To: Members of the Board of Architectural Review

Re: Sep 16, 2021 - Docket #12 & 13 BAR #2021-00455 & 2021-00456 OAH

VIEW OF EAST AND NORTH ELEVATIONS

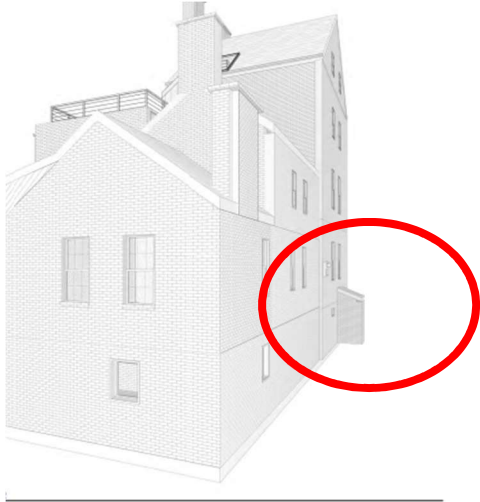
This note is about the north elevation cellar door entrance. When comparing the two photos in the application to the proposed north elevations plus the photos I took, the cellar door height and mass appears to have changed, and the distance has decreased between the window sill and the top of the cellar door. The extra height and mass do not appear to be in compliance with the Washington Street Standards, would be awkward on the side walk, and the cellar door protrusion opposite the large traffic light box would make the sidewalk feel narrow. Thank you for reviewing this note.
